OWNER:	TELANGANA STATE POWER GENERATION CORPORATION LTD. HYDERABAD - TELANGANA, INDIA			
CONSULTANT:	DESEIN PRIVATE LIMITED			
PROJECT:	BHADRADRI THERMAL POWER STATION 4 x 270 MW, UNITS-1 TO 4, MANUGURU, TELANGANA, INDIA			
EPC CONTRACTOR:	BHARAT HEAVY ELECTRICALS LIMITED INDUSTRIAL SYSTEMS GROUP ISG-BANGALORE			
TITLE:	G.A OF TP-3 WITH LOAD DATA			
SCALE:	BHEL JOB NO. IS-1-14-2007			
	BHEL-ISG IS-1-GA-691-104-M021 DRG.NO.:			
				REV. 01

COMPLIANCE TO COMMENTS OF DESEIN

ON GA DRAWINGS OF TP-3 R0 SUBMITTED BY BHEL FOR APPROVAL

Ref:	Comments made on GA Drawing prints of TP-3, IS-1-GA-691-104-M021, R0 by DESEIN		
SL NO	DESEIN COMMENTS.	COMPLIANCE / CLARIFICATIONS BY BHEL	REMARKS
	COMMENTS MARKED MEMO		
1	Monorail shall be projected 3 m from the out side sheeting of the transfer tower. Please correct.	Noted & revised.	
2	Please indicate the down comer and tramp iron chute clearance from the ground level.	Indicated	
3	Please include details of 1 ton hook provided at various places in the hoist schedule.	In hoist schedule, only details of hoist will be indicated. However, capacity & location is indicated in resp plan & elevation view & same shall be taken care by our civil in drgs.

Project : BHADRADRI POWER 4x270MW TELANGANA
Client : TELANGANA STATE POWER GENERATION CORPORATION LTD.
Consultant : DESEIN PRIVATE LTD.
Contractor : BHARAT HEAVY ELECTRICALS LTD.

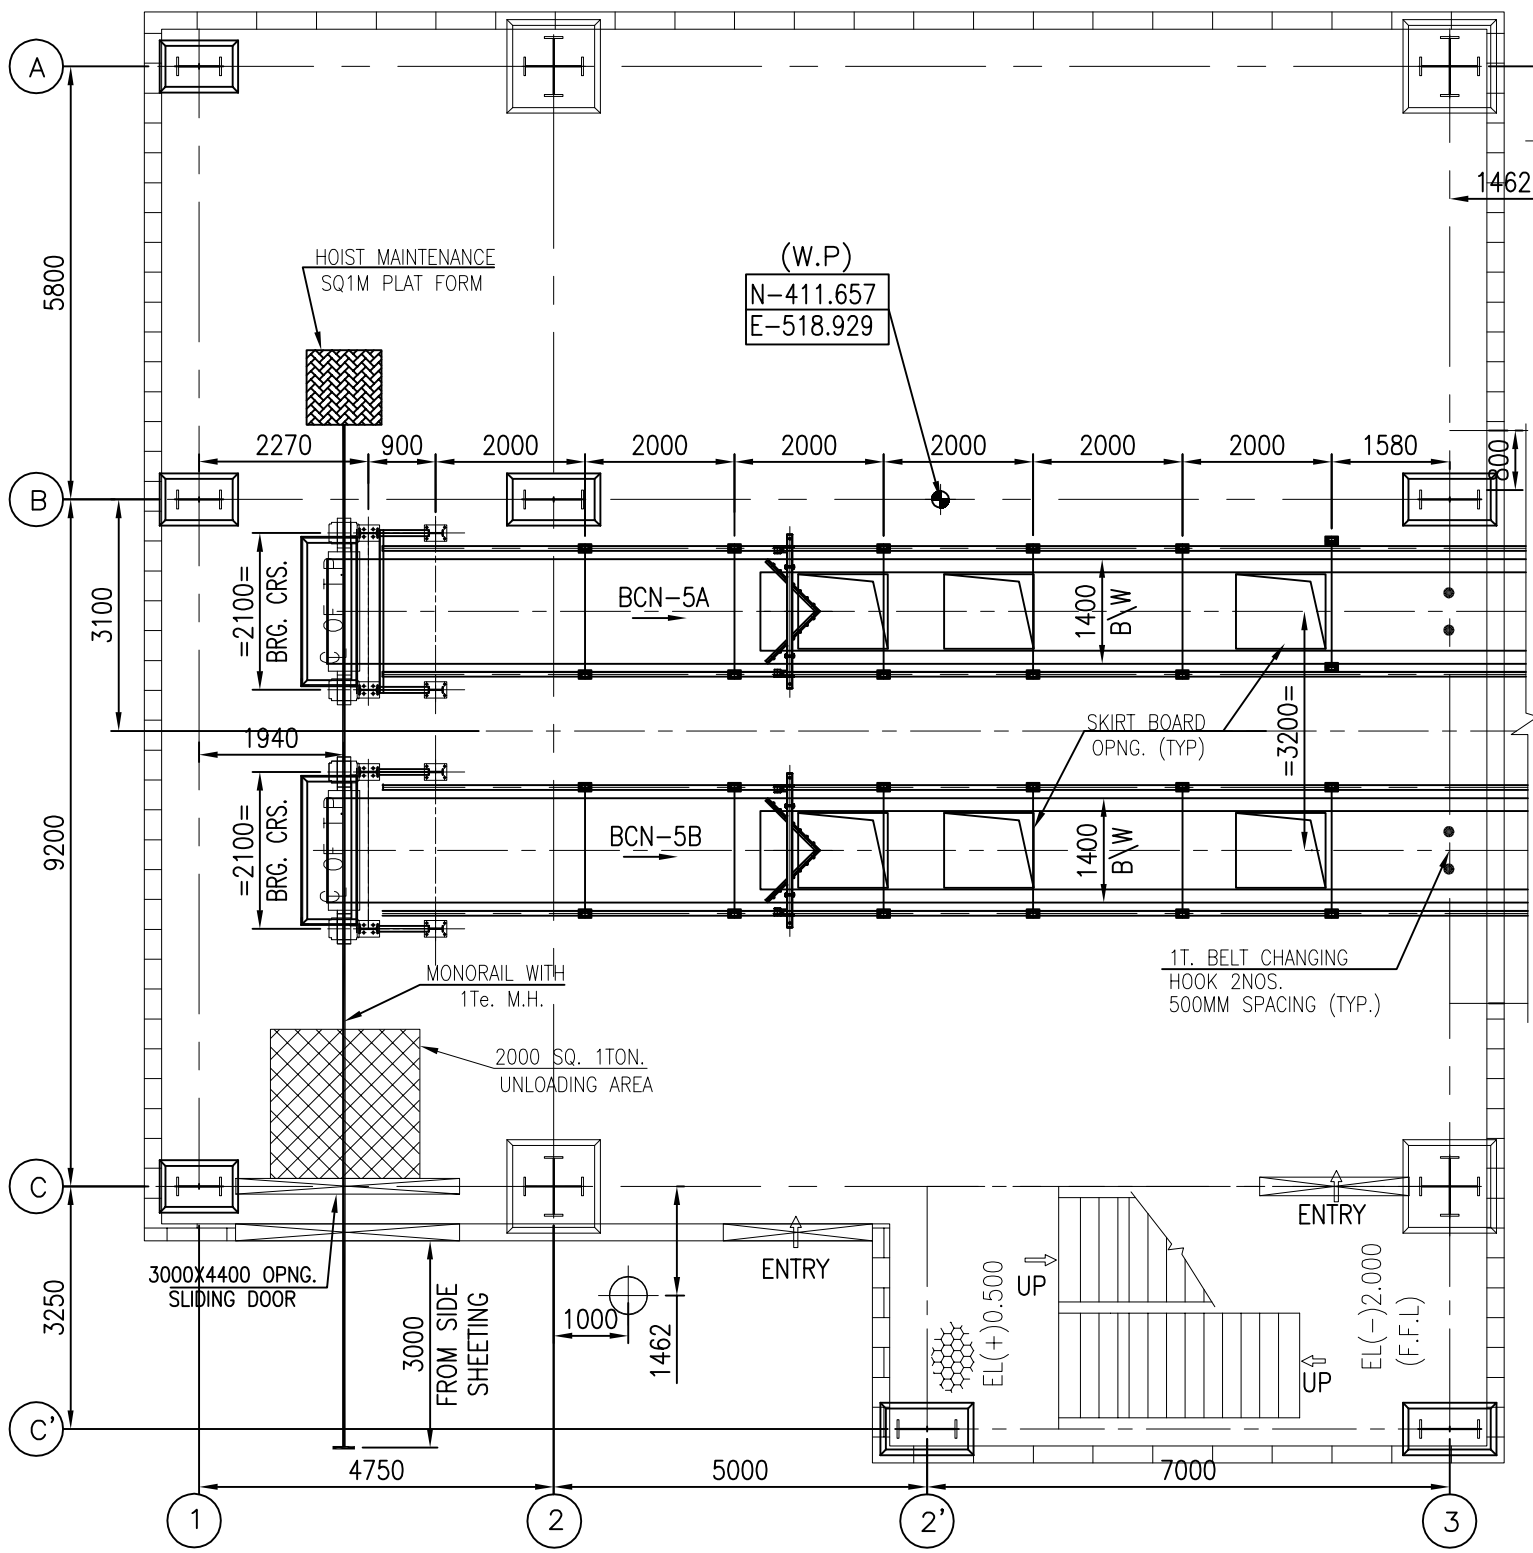
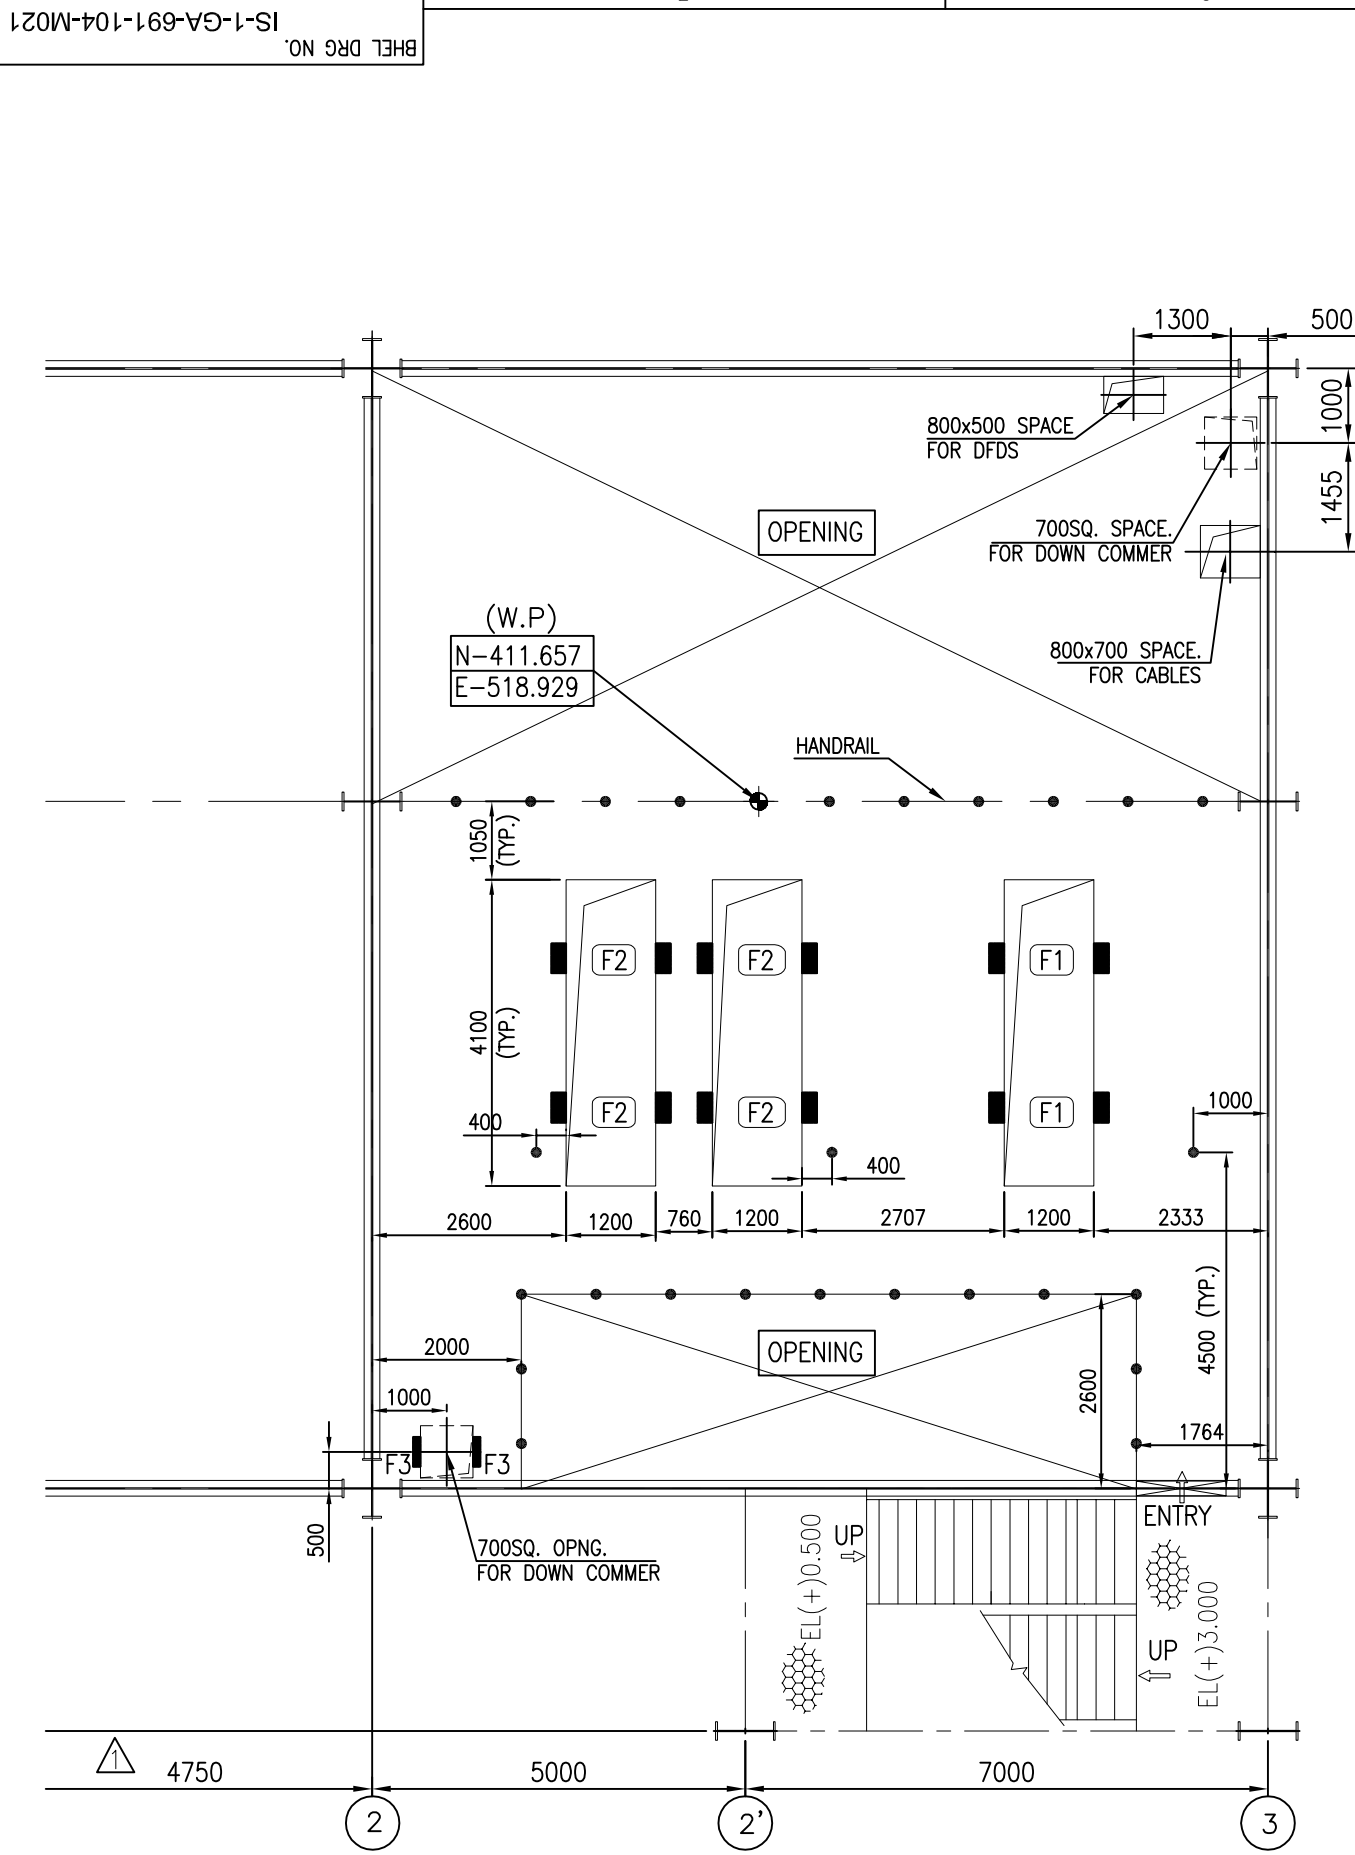
6	Please submit power tension calculations of BCNs coming in the transfer tower along with the GA's.	Already submitted.	
7	Please provide a note that curb wall will be provided around all openings	Noted & revised.	
8	Please provide side cladding details, equipment list along with their loads.	Shall be furnished in respective drgs. of civil / structural drgs.	
9	Please indicate chute vibrators and provide its details.	Indicated	
10	Inspection doors shall be leak proof. Please add	Noted.	
11	Anchor bolt plan may be corrected as foundation plan as not anchor bolt details are shown.	Corrected	
12	Refer machinery and anchor bolt plans: Please indicated the type of floor.	Indicated	
13	Please indicate height of skirt board and projection of skirt board in forward & reverse direction & give dimension.	Indicated	
14	Please confirm monorail routed is passing over CG of equipments to be handled.	Whereever possible to maximum extent, monorail routing has been done.

15	Openings for debris chute, DS/SW/DW pipes etc to be shown in all floors.	Indicated	
16	Please indicate north orientation in all the drawings.	Indicated	
17	Please indicate all the distances from the working point	Indicated	
18	Water tank shall be provided on a pedestal. Please indicate the same.	Indicated	
19	Please check and correct the angle of T.I in conveyors.	Indicated inline with already conveyor drgs. submitted.	
20	Refer GA of TP-3- Plan at EL(+)3.000M: Roof above the tail end of the conveyor shall be indicated.	Indicated
